BRUNSWICK STEAM ELECTRIC PLANT, UNIT NOS. 1 AND 2
DOCKET NOS. 50-325 AND 50-324
LICENSE NOS. DPR-71 AND DPR-62
RESPONSE TO REQUESTS FOR ADDITIONAL INFORMATION
SPENT FUEL POOL STORAGE MODIFICATION

CAROLINA POWER & LIGHT COMPANY (CP&L) RESPONSES TO
ADDITIONAL QUESTIONS REGARDING THE
BRUNSWICK STEAM ELECTRIC PLANT (BSEP) UNIT NOS. 1 AND 2
SPENT FUEL POOL STORAGE EXPANSION

36 CELL RACKS:SECTION 1.0 - SRSS MODAL RESPONSESPECTRUM ANALYSIS OBESEISMIC MATHEMATICAL MODEL

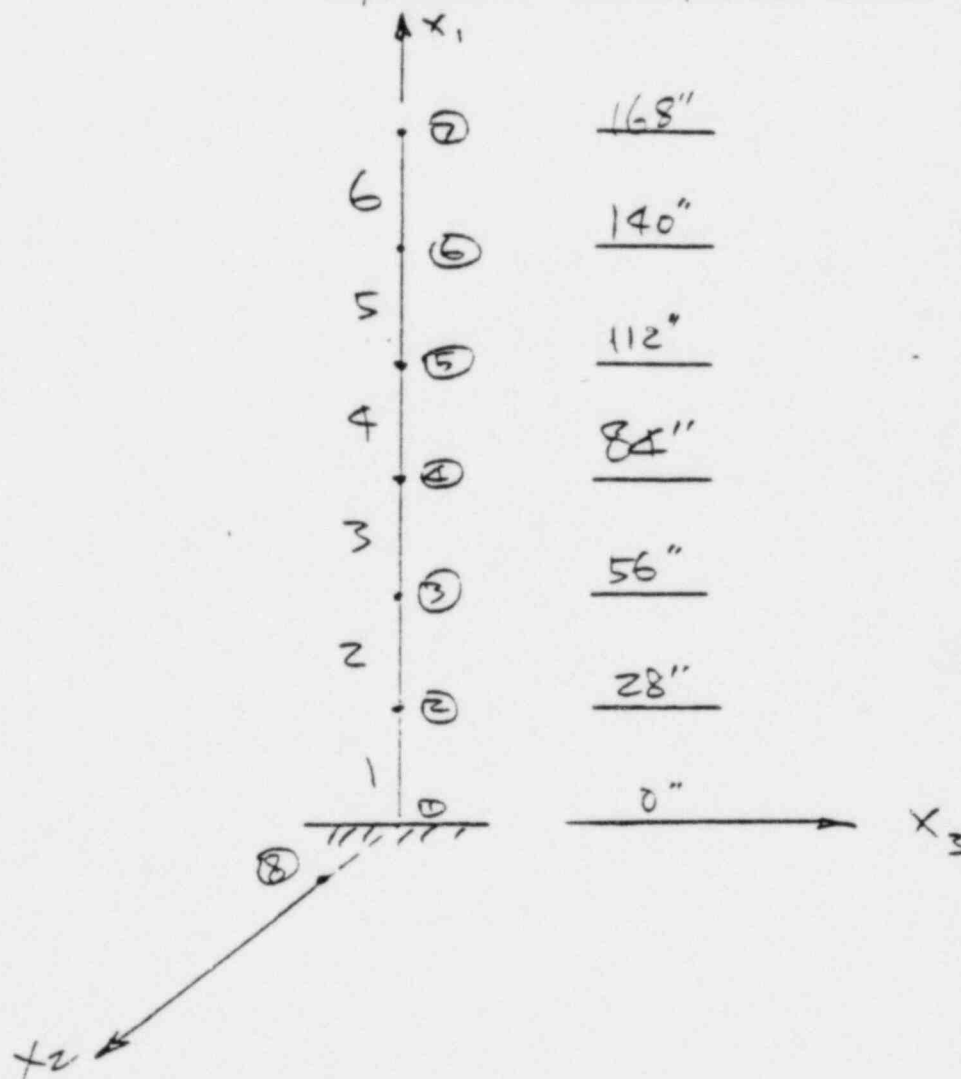
Provide details and results of the analysis of the effects of the new rack loads on the pool structure. Include a sketch of the mathematical model.
